Connected Asset Commissioning, Testing and Information Standard (CACTIS)

Decision paper and addendum

31 March 2026

Figure 1: Comparison of asset dynamic response under current capability, tolerance limits, and potential capability changes.

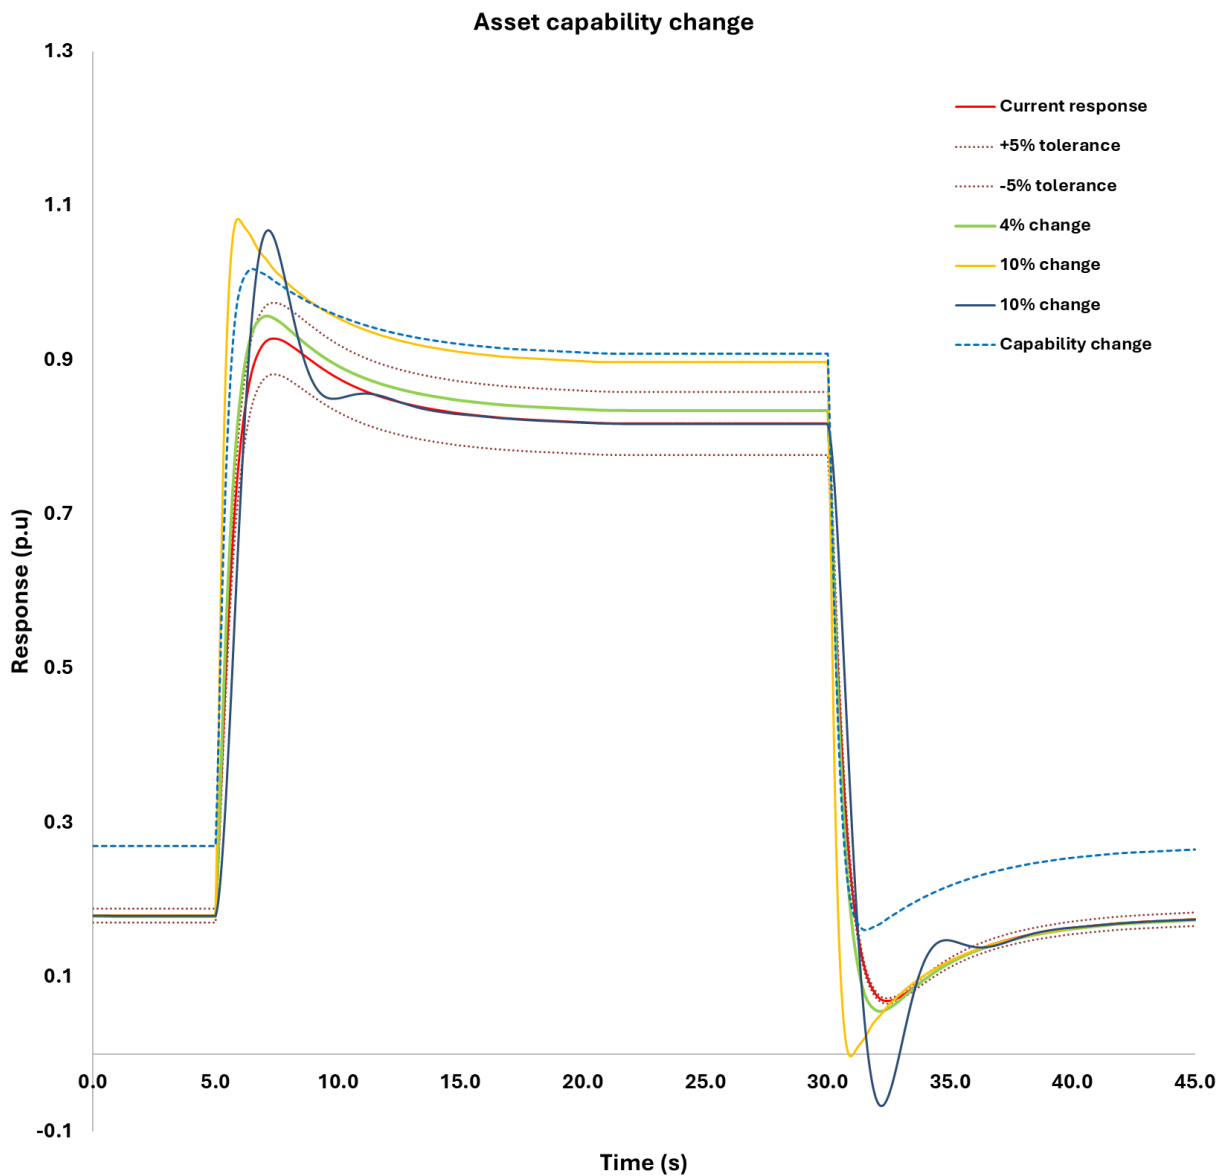
3.80. To address the risk that routine testing or refurbishment may be unintentionally classified as a modification, the Authority has clarified that, unless the System Operator and the asset owner agree otherwise, an alteration to an asset will be considered a modification for the purpose of the legacy clause arrangements if it results in a change of 5% or greater in the asset's:

- (a) MW rating, or
- (b) frequency response curve for 100 milliseconds or longer, or
- (c) voltage response curve for 100 milliseconds or longer.

3.81. Figure 1 illustrates how alterations to an asset's output—specifically $\pm 5\%$ tolerance bands and example changes of 4% and 10%—affect its time-domain response. Responses that remain within the $\pm 5\%$ tolerance band illustrate changes that would not constitute a modification, while responses exceeding these bounds represent changes that would be treated as modifications for the purpose of the legacy clause arrangements.
